Kansas Department of Agriculture
 Division of Water Resources
CHANGE: P/U WORKSHEET

RE: Approval of Application for Change
Water Right, File Nos. 6032, 32443, 33039

DWR FIELD OFFICE APPLICATION FOR APPROVAL TO CHANGE THE PLACE OF USE AND/OR THE POINT OF DIVERSION

RE: Applications for Change in Place of Use
Water Right, File Nos. 6032, 32443 & 33039

Change in place of use application for water right 6032

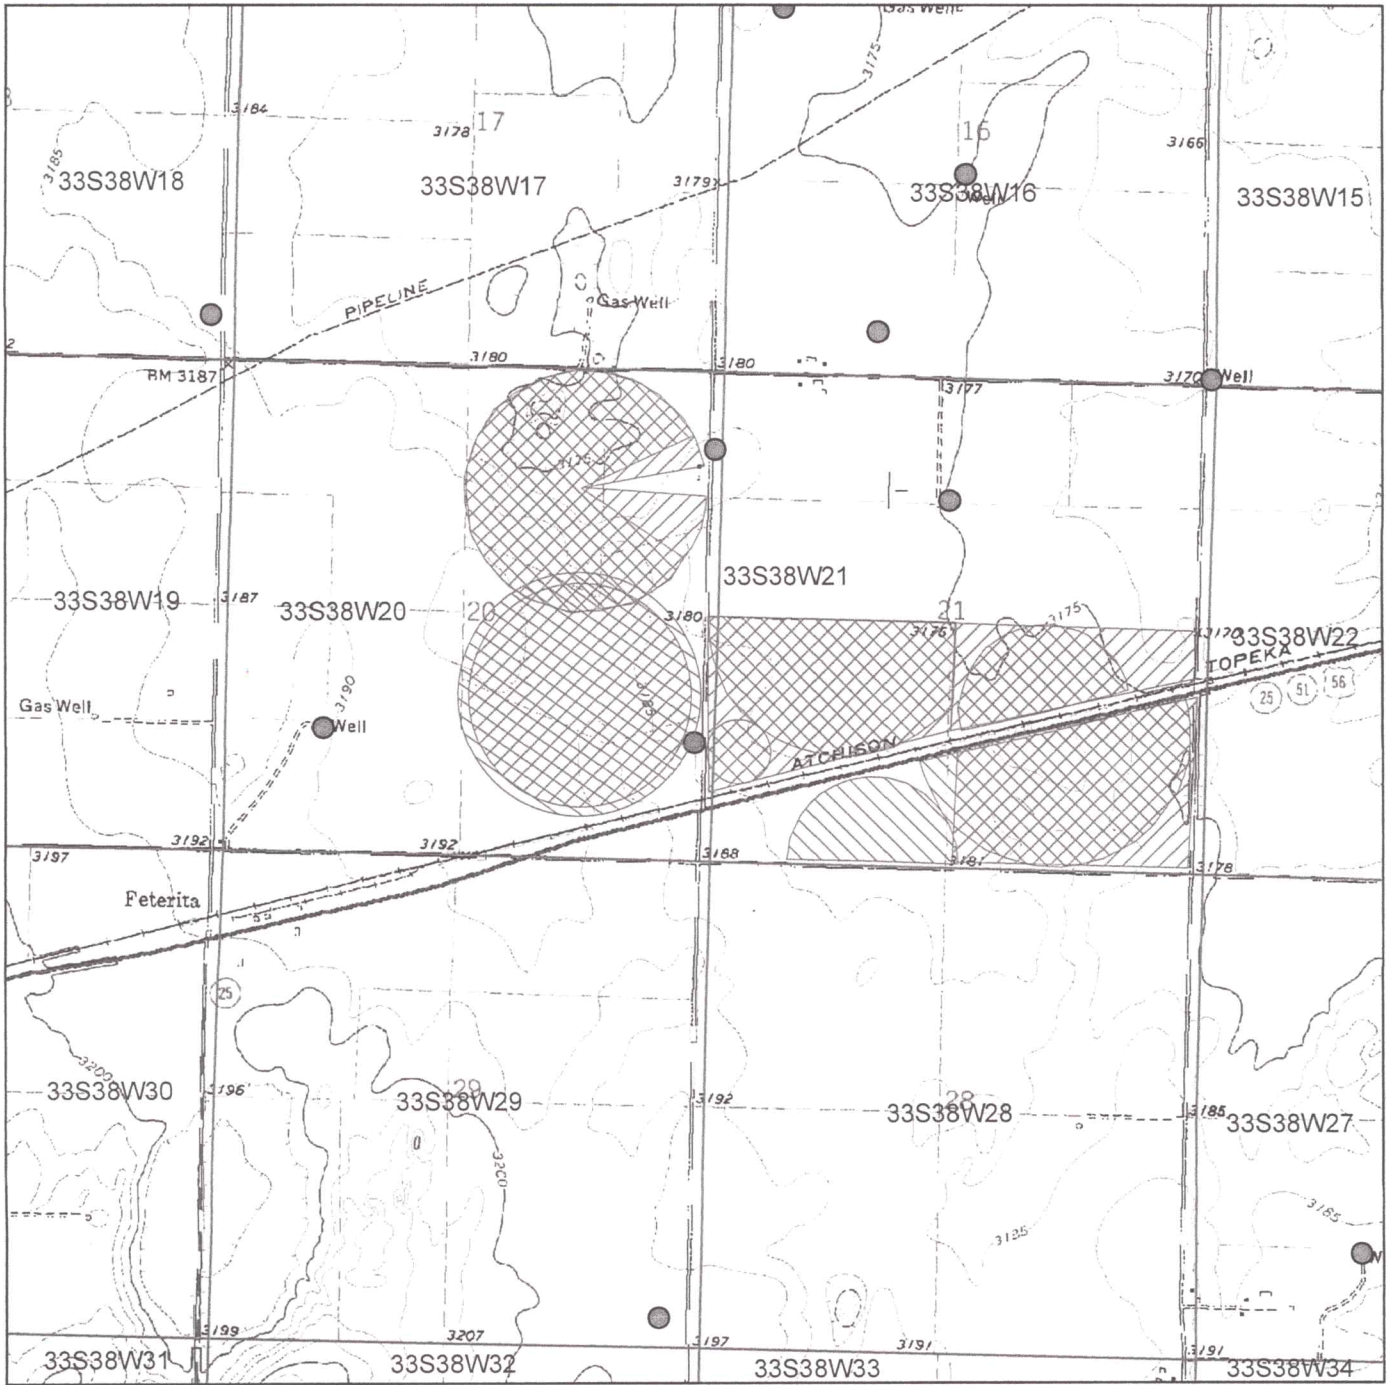
Is Proposed PU overlapping existing WRs? Rearrange acres for operation, will be complete overlap.

All three WRs currently overlapped in PU.

Current authorized acres: 219 Section 20-33-38

231.5 Section 21-33-38

Proposed acres: 450.5 acres, but rearranged

Proposing no more acres than currently authorized and is only 9.5 acres over combined base acres.

Is a waiver needed: Authorizing 9.5 acres over combined base.

Recommendation: After review of all available information, it appears current area rules are met. Staff therefore recommends approval of the applications.
